SITE INSTRUCTION

PROJECT: HAMPTON MANOR
25 BAKER HILL BLVD
STOUFFVILLE, ONTARIO

SITE INSTRUCTION: M-14

Purpose: To suit architecture suite layout changes.

TITLE PART 5TH FLOORS PLAN MECHANICAL			
PROJECT 25 BAKER HILL BLVD. ROYAL PINE HOMES			
STOUFFVILLE, ONTARIO PROPOSED RESIDENTIAL DEVELOPMENT			
DRAWN GC	CHECKED BT	SCALE 1:100	
DATE JUNE 2015	PROJECT 14-016	DRAWING M-20	OF 42

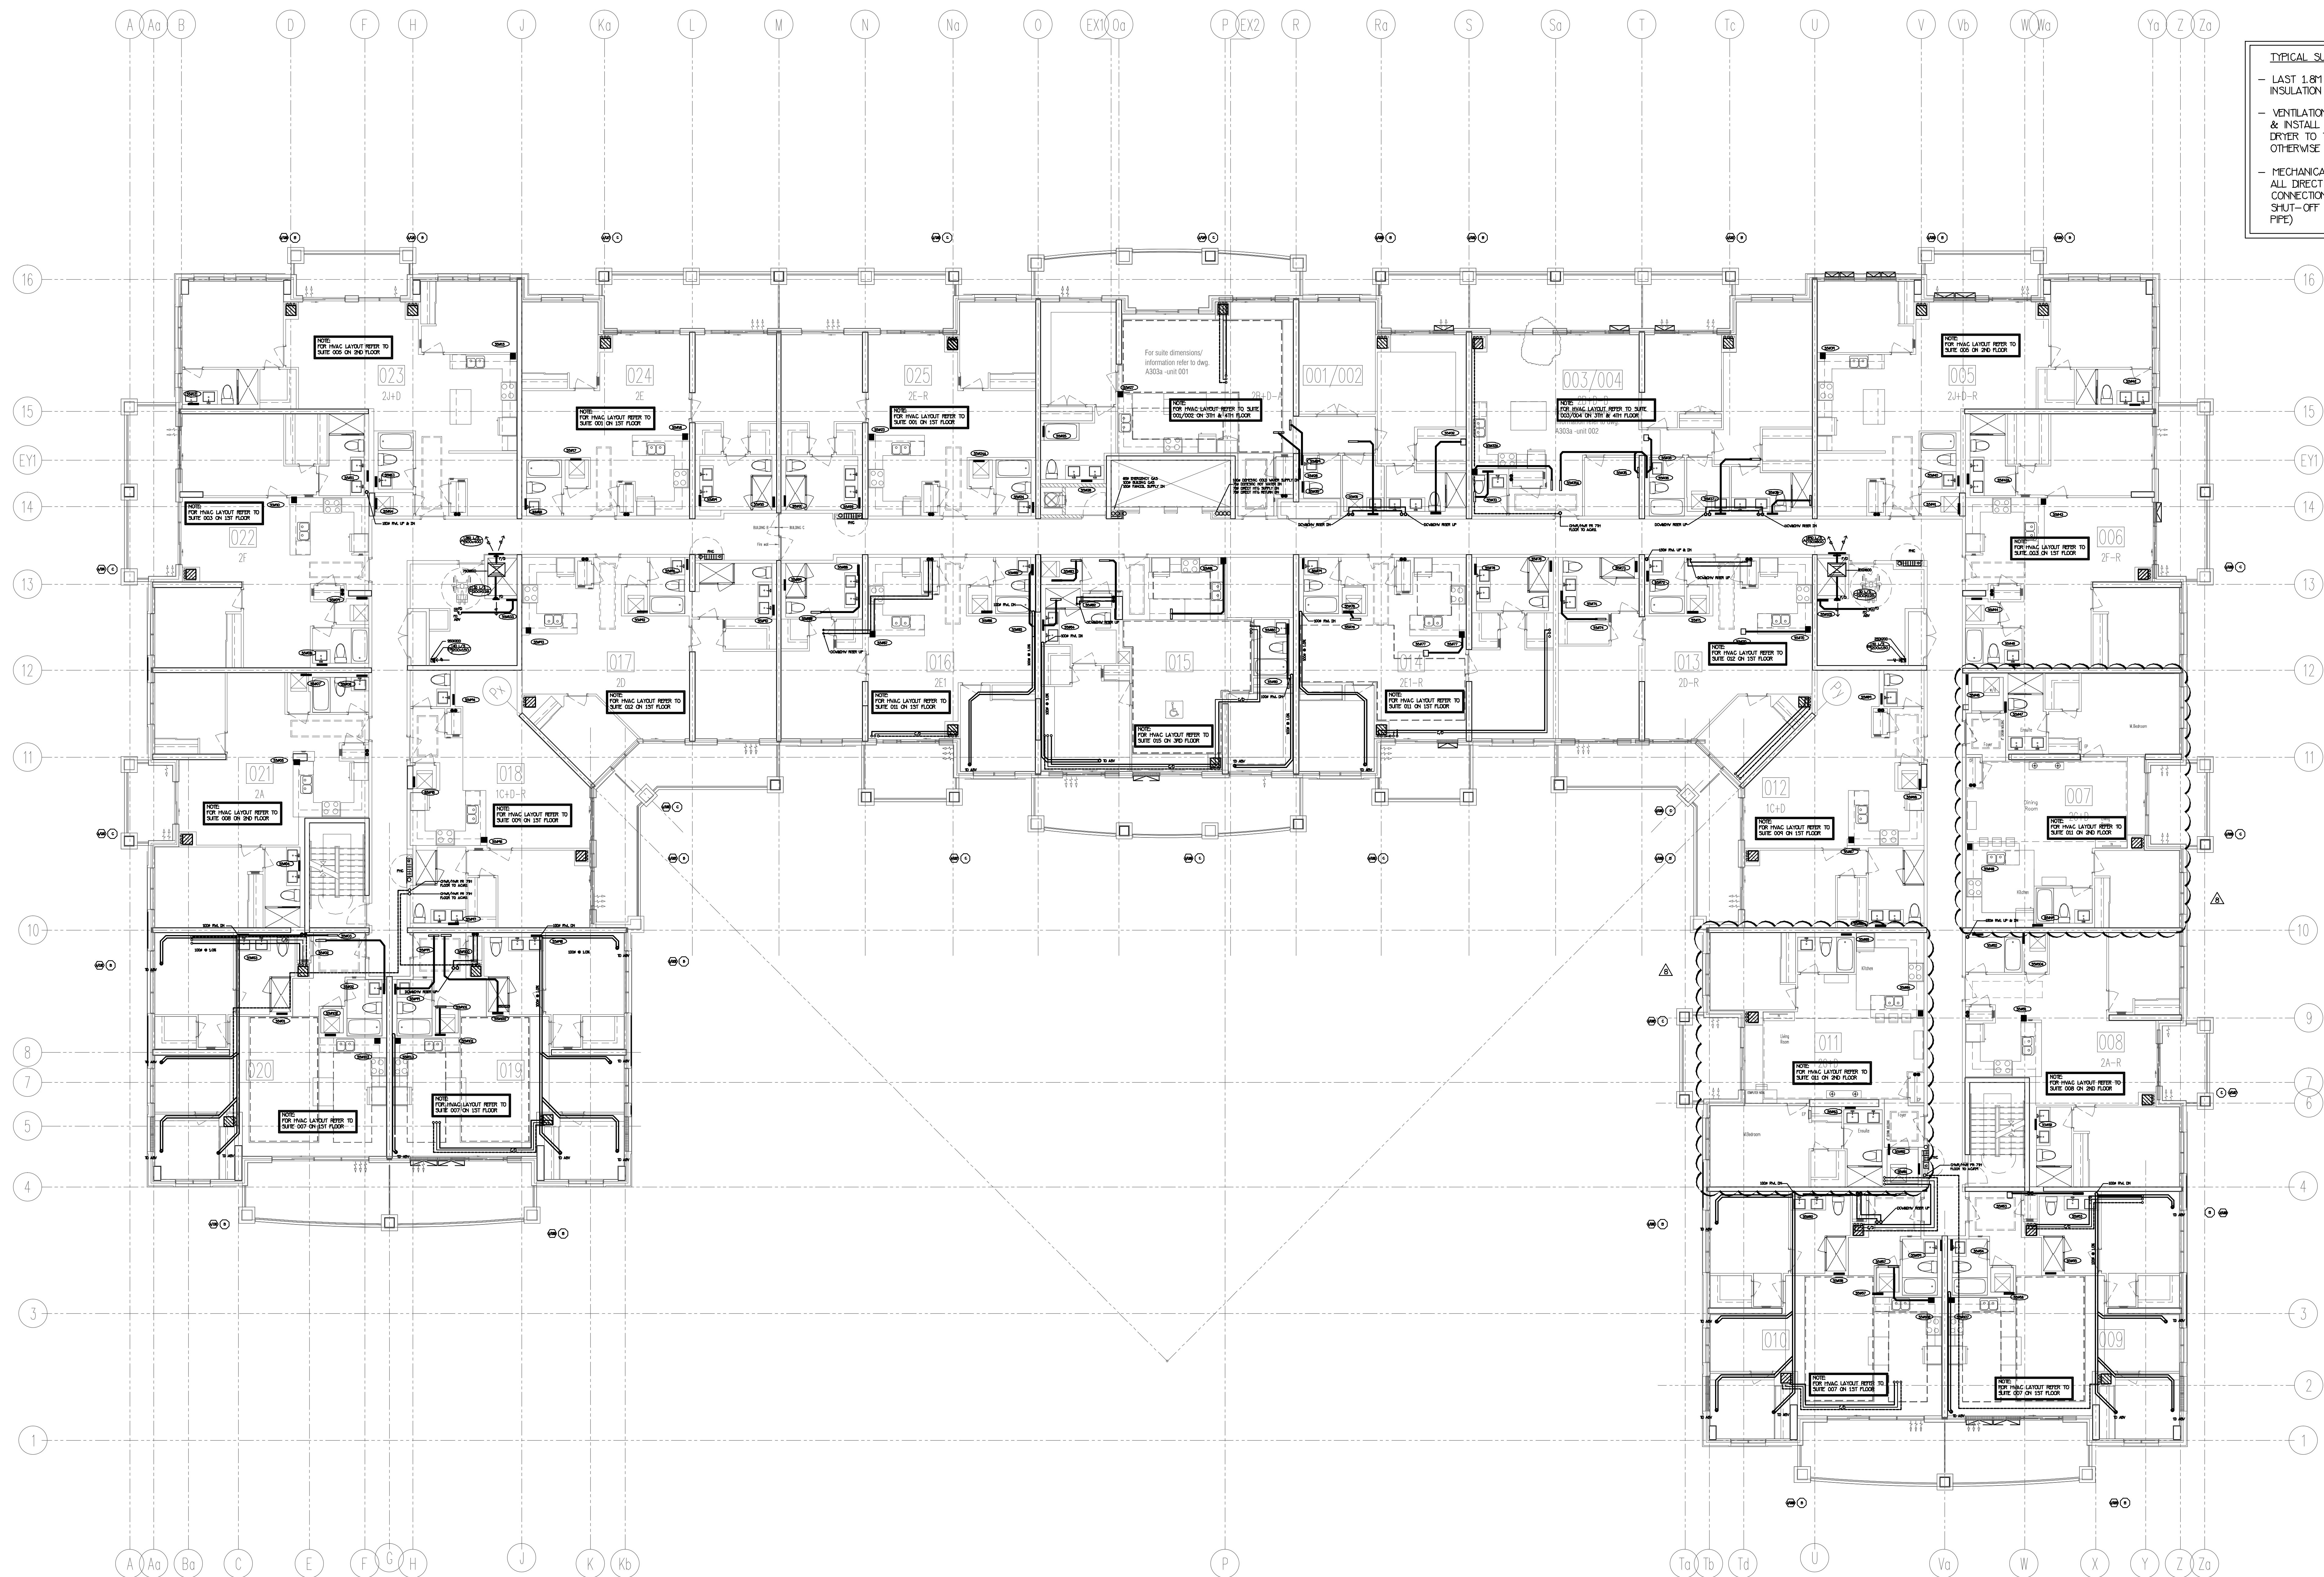
4.0 Reference Drawing M-20, M-23, M-24 (5th Floor - Mechanical) Issued

4.1 Revised: Mechanical layout at suite 507, 511.

TITLE			
PART 6TH FLOORS PLAN MECHANICAL			
PROJECT			
25 BAKER HILL BLVD. ROYAL PINE HOMES			
STOUFFVILLE, ONTARIO		PROPOSED RESIDENTIAL DEVELOPMENT	
DRAWN	GC	CHECKED	ST
DATE	PROJECT	SCALE	DRAWING
JUNE 2015	14-016	1:100	M-25
			OF 42

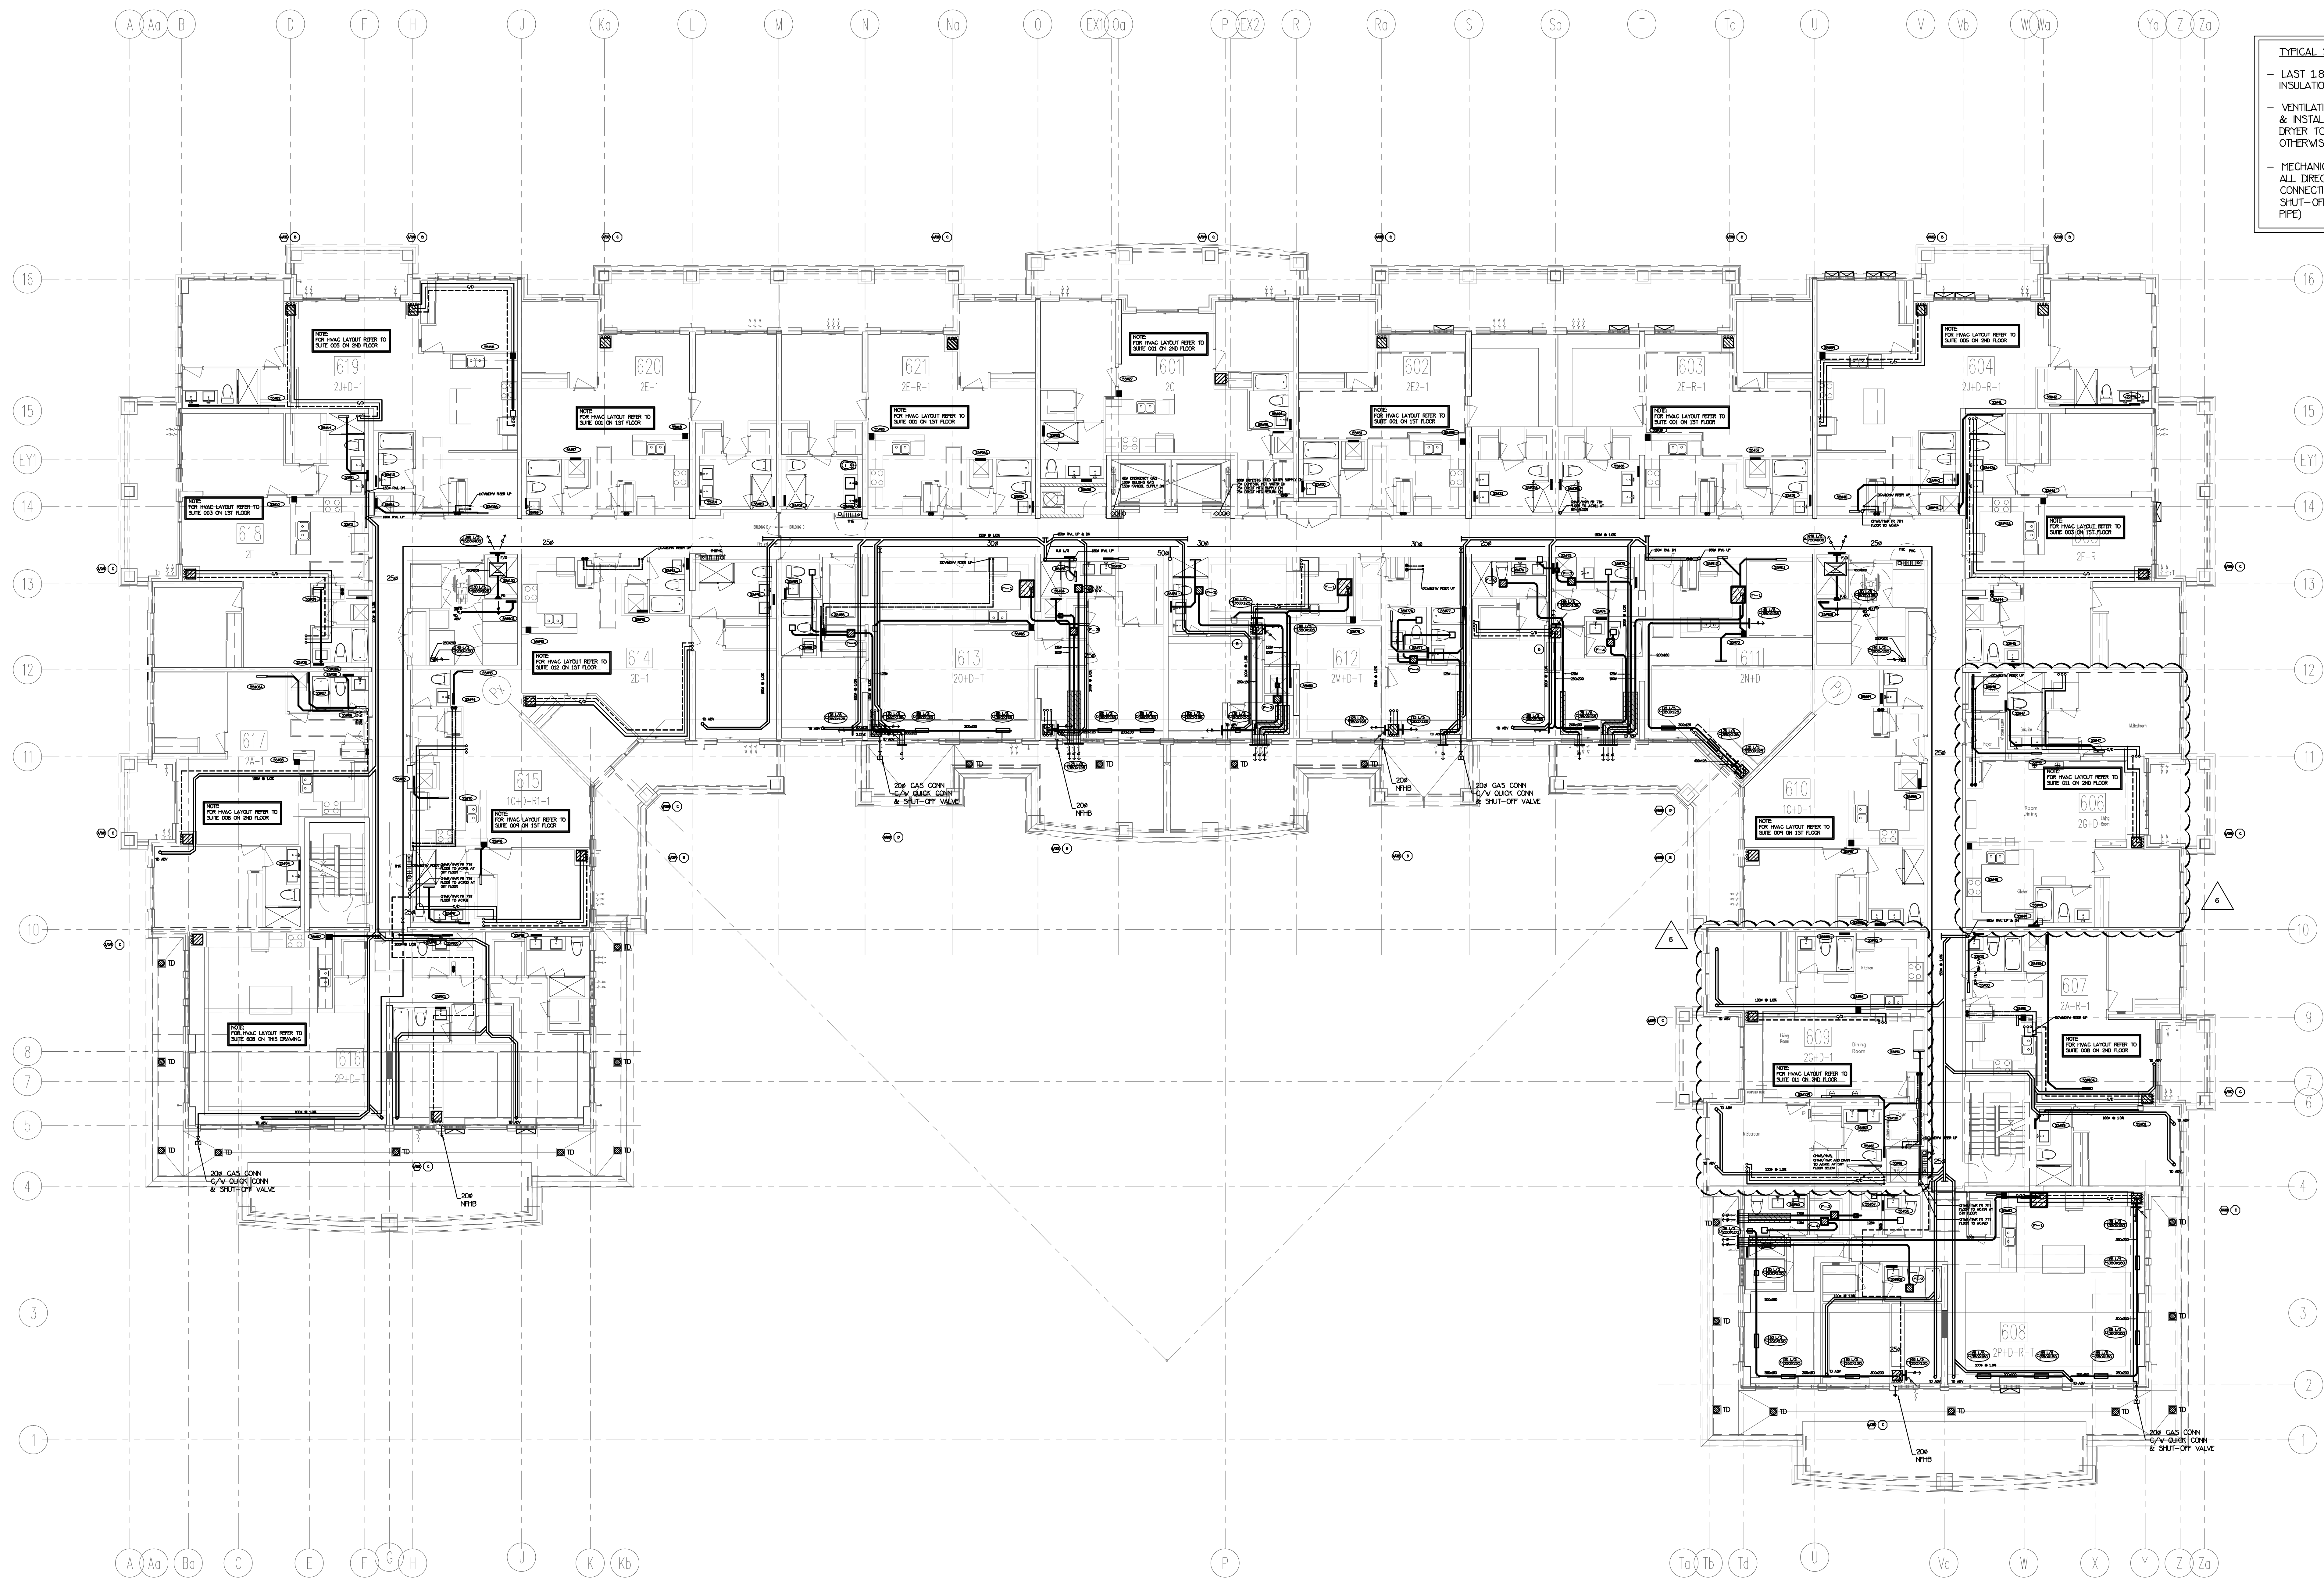
5.0 Reference Drawing M-25, M-28, M-29 (6th Floor - Mechanical) Issued

5.1 Revised: Mechanical layout at suite 606, 609.
